BUILDINGS 5 & 6 RENOVATIONS

CAÑADA COLLEGE
 4200 Farm Hill Boulevard
 Redwood City, CA 94061

MECHANICAL
 DUCTWORK PLAN
 FIRST FLOOR

Date 08/29/08
 Scale AS NOTED
 Project Number 07013
 Drawing Number M2.1d

MSK-10

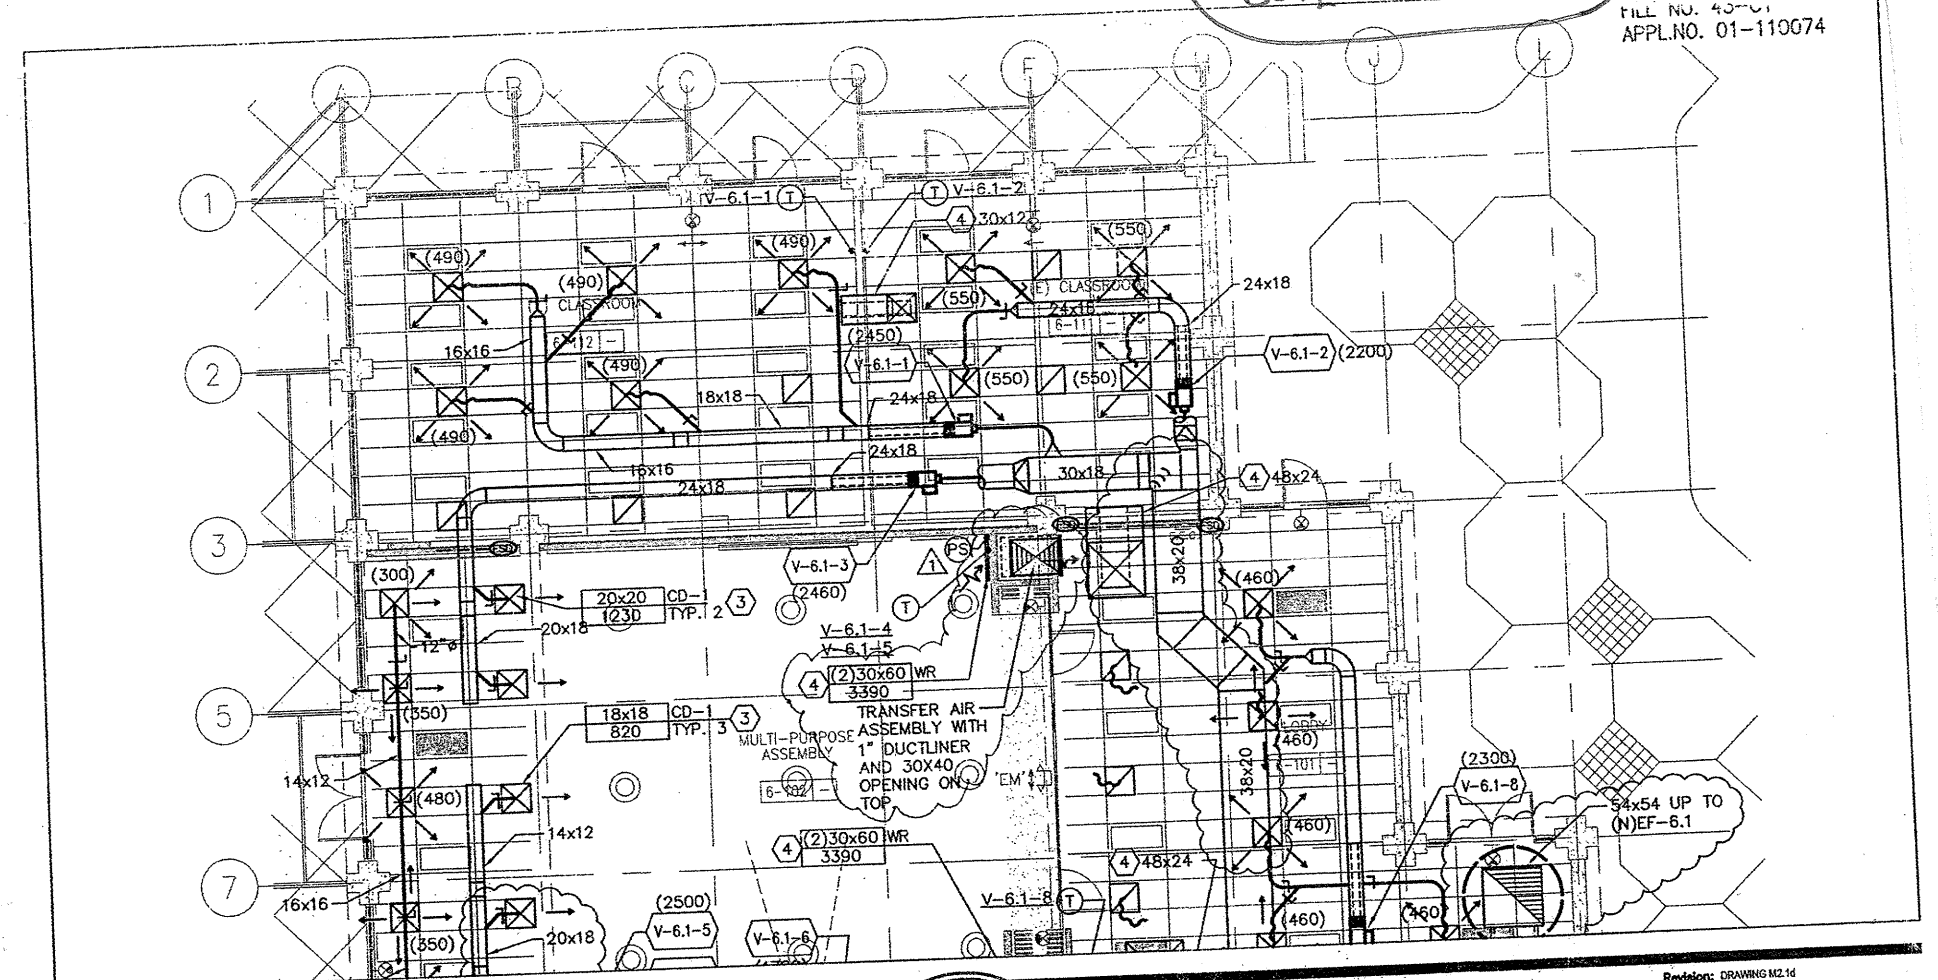
CTOR SHALL PROVIDE FULL SIZE PLENUM, 24" DEEP FROM FACE USER.
 INACTIVE SECTIONS OF SD-1 BETWEEN ACTIVE SECTIONS OF R TO ACHIEVE A CONTINUOUS LENGTH.
 LENGTH OF SUPPLY DIFFUSER IS 5'-0" LONG. PROVIDE FULL OUSTICALLY LINED PLENUM 2 FEET DEEP FROM DIFFUSER FACE.
 TRANSFER AIR BOOT. SEE DETAIL 8/M601.
 LENGTH OF TRANSFER AIR REGISTER IS 5'-0" LONG. PROVIDE NGTH ACOUSTIC TRANSFER AIR BOOT. SEE DETAIL 8/M601.

DUCT CHANGES

RFI-239
 FSD in Hardlids
 REF. RFP 38

SEE
 MSK-14
 RFI-241

RFI-236
 CEILING HEIGHT
 VS. TRANSFER
